Access Compliance Report

Public Rights-of-Way

(Curb Ramps)

Intersection ID: 12431	Main Street: S_CHURCH_ST	Cross Street: W_MARTIN_LUTHER_KING_JR_BV	Location: W
ADA ID: E796F5BC047C	Ramp Type: Perp	Initial Pass/Fail: Fail	Overall Compliance: No
Severity Score: 12.5			
Codes/Mitigation Info/Possible Solution		Field Measurements/Component Compliance

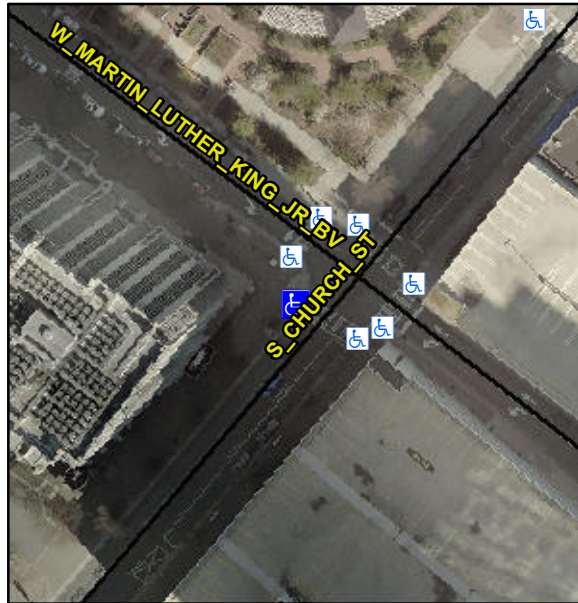
Compliance	Description	Data	Compliance	Description	Data
N/A	Ramp Length (in)	65.0	No	Ramp Slope (%)	9.6
Yes	Ramp Width (in)	48.0	Yes	Ramp XSlope (%)	0.8
N/A	Flare Type LT	N/A	N/A	Flare Type RT	N/A
N/A	Flare Slope LT (%)	N/A	N/A	Flare Slope RT (%)	N/A
N/A	Flare Traversable LT?	N/A	N/A	Flare Traversable RT?	N/A
N/A	Landing Length (in)	N/A	N/A	DWS Provided?	N/A
N/A	Landing Width (in)	N/A	N/A	DWS Contrast?	N/A
N/A	Landing Slope (%)	N/A	N/A	DWS Length (in)	N/A
N/A	Landing X Slope (%)	N/A	N/A	DWS Full Width?	N/A
N/A	Landing Curb? (Y/N)	N/A	N/A	DWS Offset (in)	N/A
N/A	Shared Landing?	N/A			
N/A	Gutter Ponding?	N/A	N/A	Gutter Slope (%)	N/A
N/A	Gutter Lip Ht (in)	N/A	N/A	Gutter X Slope (%)	N/A
N/A	Painted X Walk1?	Yes	N/A	Painted X Walk2?	N/A
	X Walk 1 Direction	To SE		X Walk 2 Direction	N/A
N/A	X Walk 1 Width (in)	110.0	N/A	X Walk 2 Width (in)	N/A
	X Walk 1 Slope (%)	0.6		X Walk 2 Slope (%)	N/A
	X Walk 1 X Slope (%)	0.7		X Walk 2 X Slope (%)	N/A

Remove & Replace Entire Ramp.
